Access Compliance Report

Public Rights-of-Way

Intersection ID: 48429	Main Street: ROUSAY_RD	Cross Street: SEAMILL_RD	Location: NW
ADA ID: A281DFA21E7E	Ramp Type: PerpDiag	Initial Pass/Fail: Fail	Overall Compliance: No
		Severity Score: 25

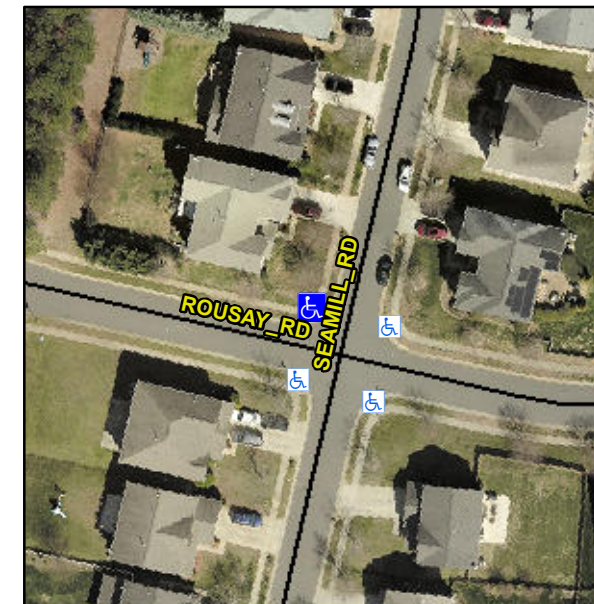
Not Found, R304.2.2, R304.5.3

Compliance	Description	Data	Compliance	Description	Data
N/A	Ramp Length (in)	45.0	No	Ramp Slope (%)	9.6
Yes	Ramp Width (in)	48.0	No	Ramp XSlope (%)	5.5
N/A	Flare Type LT	N/A	N/A	Flare Type RT	N/A
N/A	Flare Slope LT (%)	N/A	N/A	Flare Slope RT (%)	N/A
N/A	Flare Traversable LT?	N/A	N/A	Flare Traversable RT?	N/A
N/A	Landing Length (in)	N/A	N/A	DWS Provided?	N/A
N/A	Landing Width (in)	N/A	N/A	DWS Contrast?	N/A
N/A	Landing Slope (%)	N/A	N/A	DWS Length (in)	N/A
N/A	Landing X Slope (%)	N/A	N/A	DWS Full Width?	N/A
N/A	Landing Curb? (Y/N)	N/A	N/A	DWS Offset (in)	N/A
N/A	Shared Landing?	N/A			
N/A	Gutter Ponding?	N/A	N/A	Gutter Slope (%)	N/A
N/A	Gutter Lip Ht (in)	N/A	N/A	Gutter X Slope (%)	N/A
N/A	Painted X Walk1?	No	N/A	Painted X Walk2?	No
	X Walk 1 Direction	To SW		X Walk 2 Direction	To SE
N/A	X Walk 1 Width (in)	N/A	N/A	X Walk 2 Width (in)	N/A
	X Walk 1 Slope (%)	3.7		X Walk 2 Slope (%)	0.9
	X Walk 1 X Slope (%)	4.6		X Walk 2 X Slope (%)	3.3

Remove & Replace Curb Ramp With Two New Directional Ramps or Equivalent.
